GL850A History

USB2.0 4-Port Hub Controller

Rev
1.2

Title		
GL850A LQFP 48		
Size	Document Number	Rev
B	USB 2.0 HUB	1.2
Date:	Friday, August 18, 2006	Sheet 2 of 3

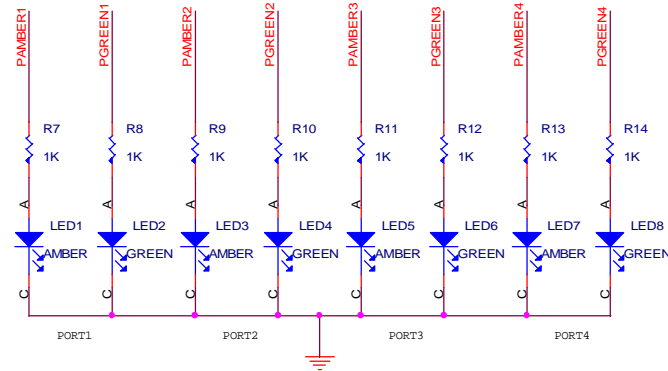
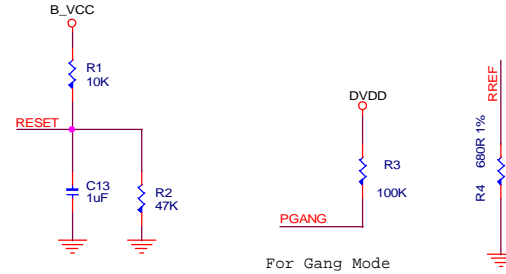
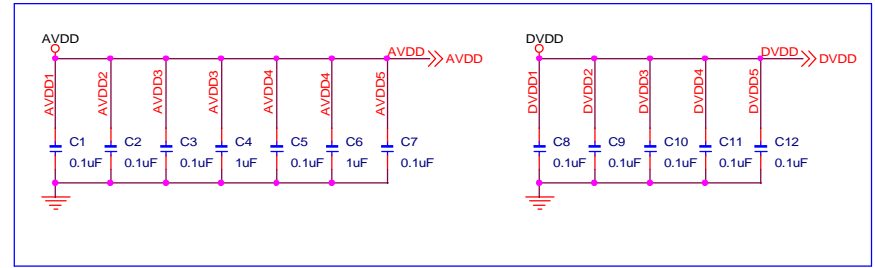
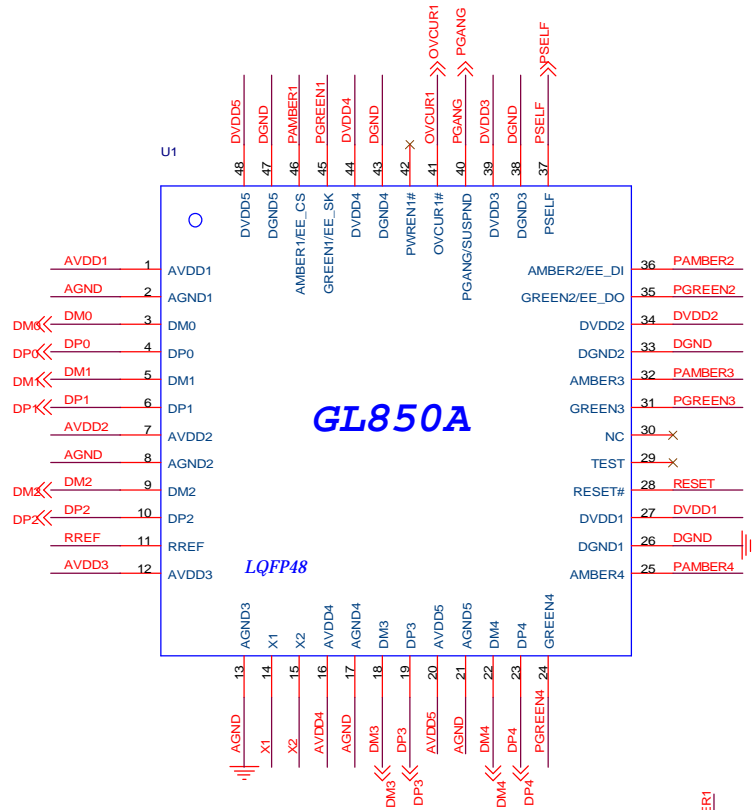
1. Changed R21 from 10K to 0 ohm.

2. Changed R25 from 1M to 20K.

2. Modify poly-fuse circuit
